*Accessibility Evaluation
for*

**City of Healdsburg, CA
Community Services and
Parks & Recreation Department**

2017

julee quarve-peterson, inc.

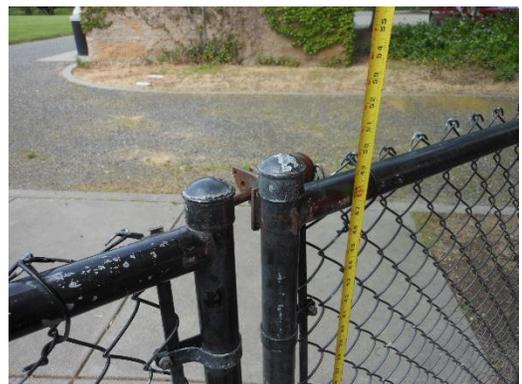
The defined play area (as well as some other site amenities including picnic tables, benches and trash) are surrounded by a fence. The gated entry currently has hardware/latch at 48" (within reach range) although it is located only the exterior side of the fence (requiring reaching over the fence to operate the hardware in order to exit).

Priority 3- Replace the operable hardware at the gate with a style that can be operated from both sides. *ADA 404.2.7*

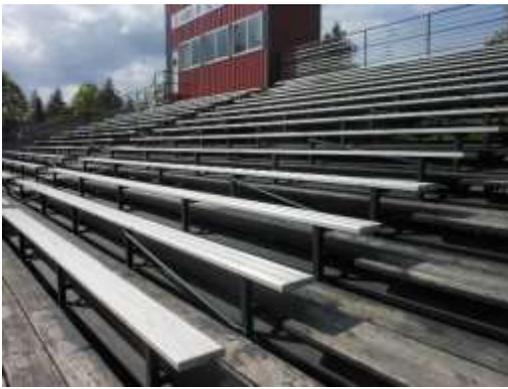
The grandstand seating has a ramp on the east end that is used by all spectators. The ramp currently has a slope of approximately 17% for its 50" rise without an intermediate level landing (vs. 8.33% maximum and a level landing for each 30" vertical rise). The surface of the ramp is wood boards which have spaces between that would allow passage of a 1/2" sphere.

Priority 1- Create an accessible route to the grandstand seating area. *ADA 206.2.4*

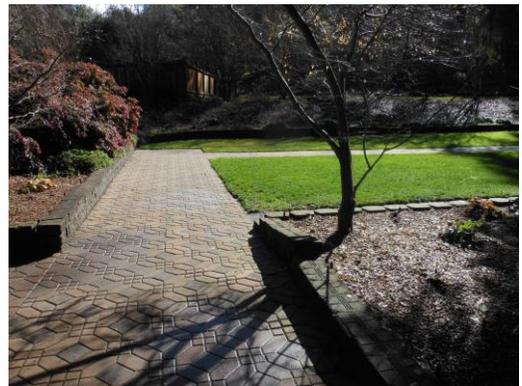
There are currently 2 steps up to the gazebo stage/platform.

Priority 3- Create an accessible route up to the gazebo stage/platform. ADA 206.2.4, 206.2.6
